Westside Purple Line Extension Project, Section 3

Addendum to the Final Environmental Impact Report

June 2018

Figure 3-3: Truck Haul Routes – Proposed

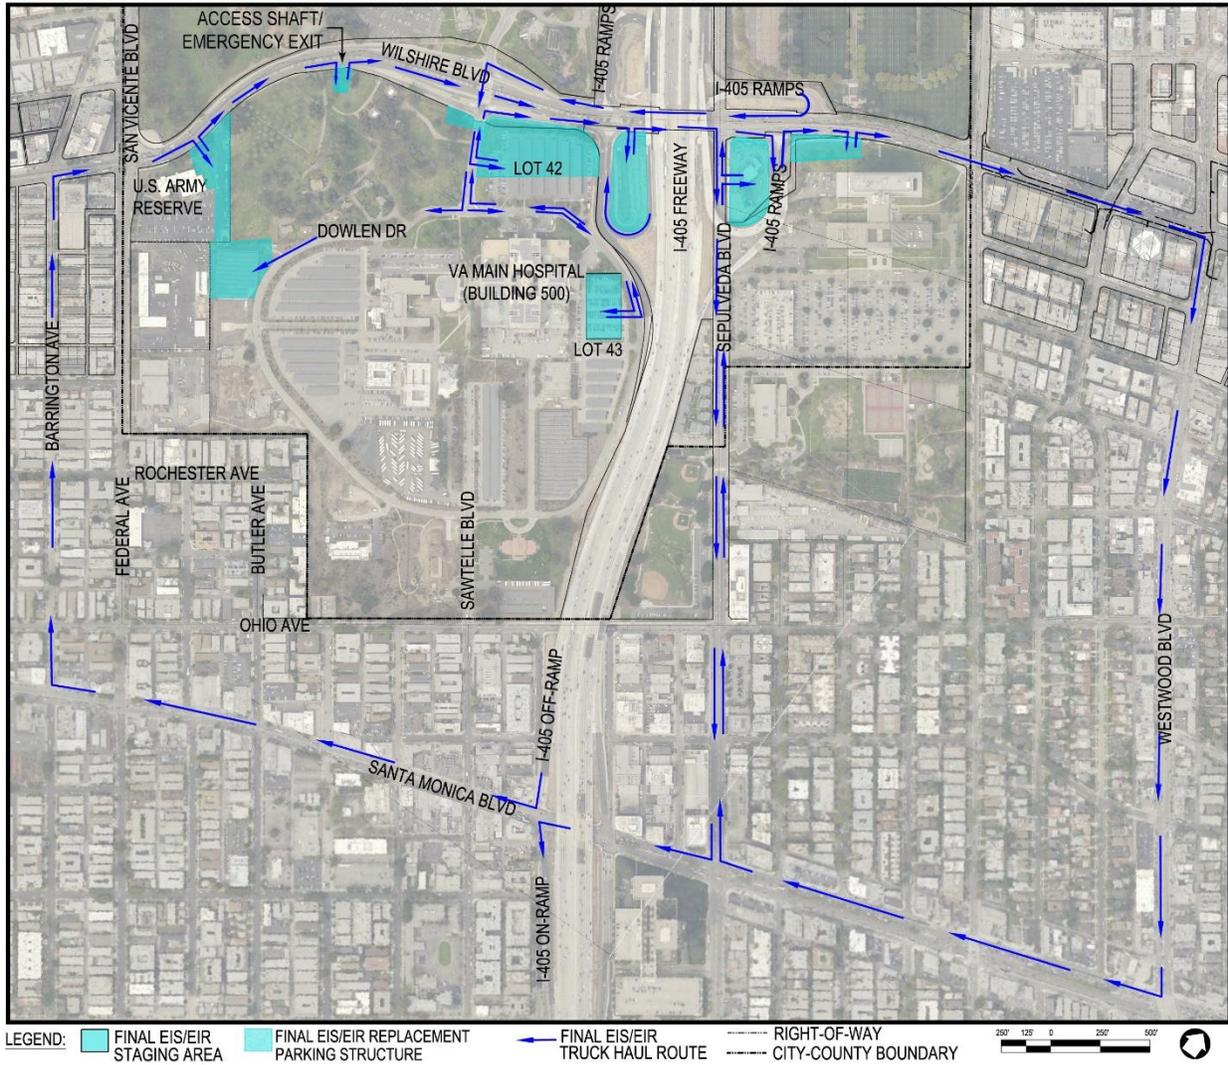
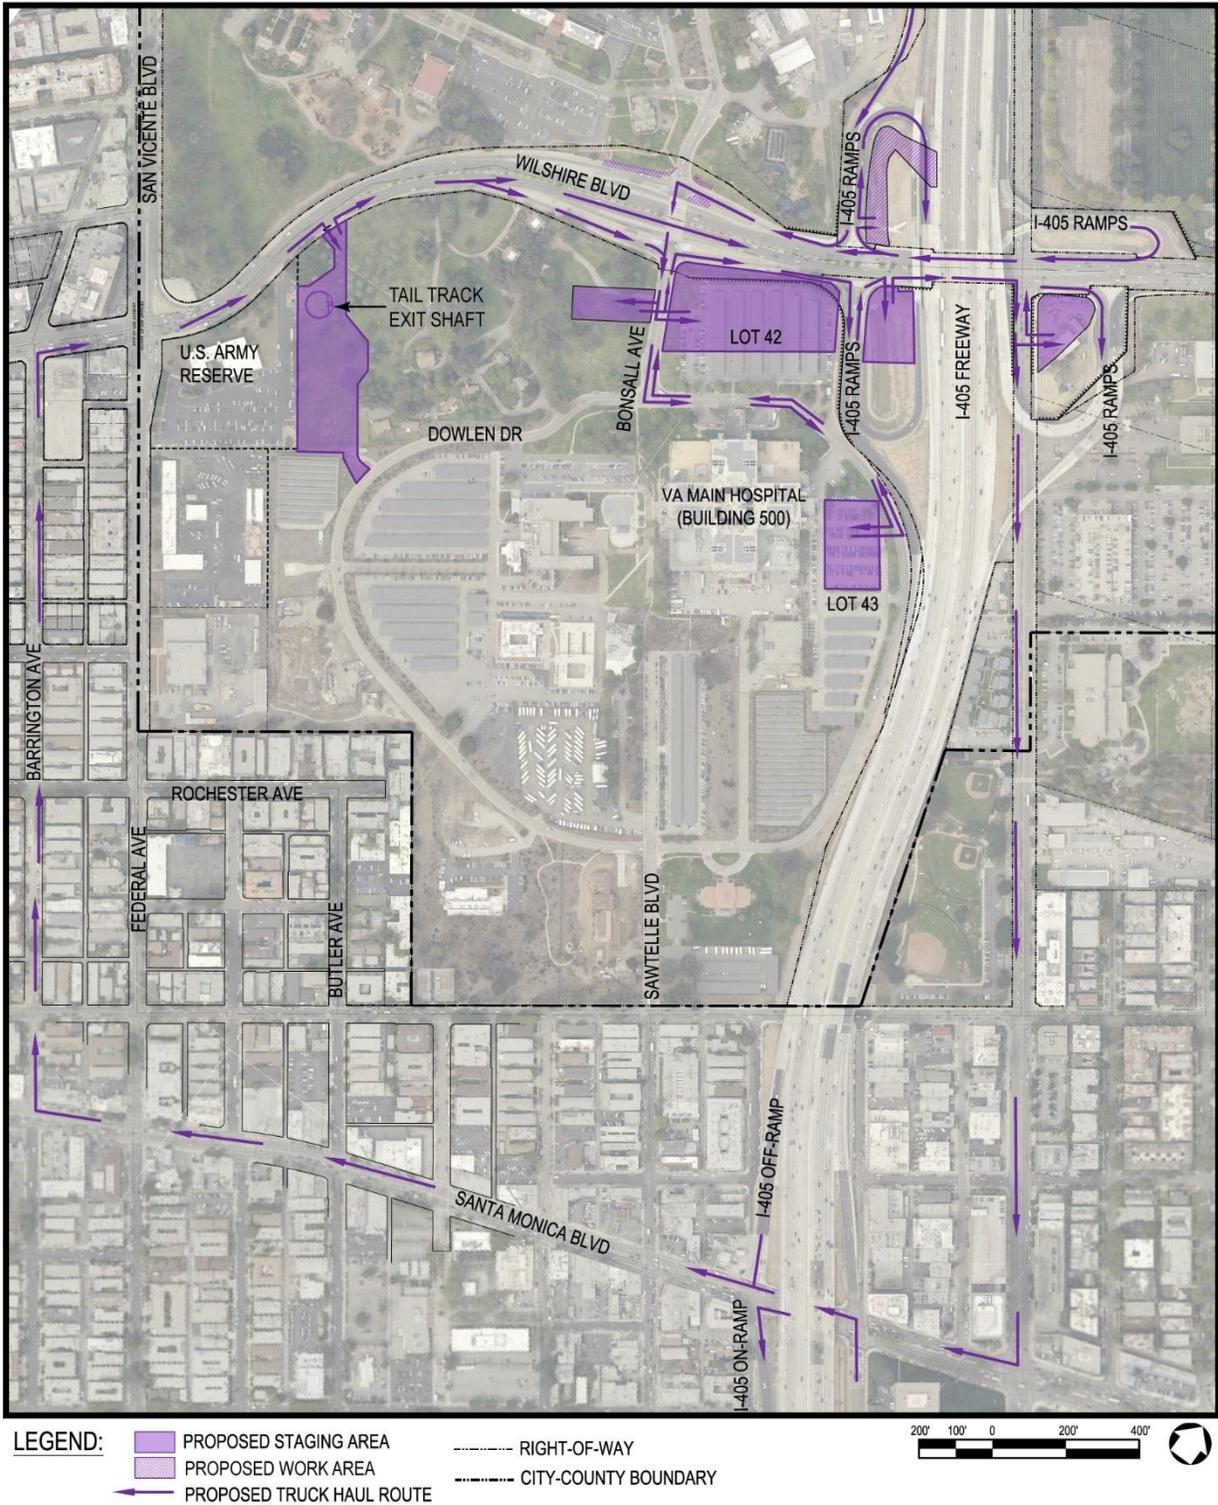
Figure 3-2 and Figure 3-3 present truck haul routes adjacent to and within the VA WLA Campus as identified in the Final EIS/EIR and proposed, respectively. Major differences between the haul routes are as follows:

- The Final EIS/EIR included truck haul routes on Dowlen Drive west of Bonsall Avenue to provide access to the construction staging area located on the west side of the VA WLA Campus adjacent to the U.S. Army Reserve site. This haul route has been eliminated to minimize truck activity on the VA WLA Campus. The construction specifications state that haul routes cannot occur on this section of Dowlen Drive, except for emergency access by the contractor.

- As shown in Figure 3-3, there would be limited haul truck activity (less than 20 trucks per day) associated with the construction staging area west of Bonsall Avenue that would support construction of the Westwood/VA Hospital west crossover.
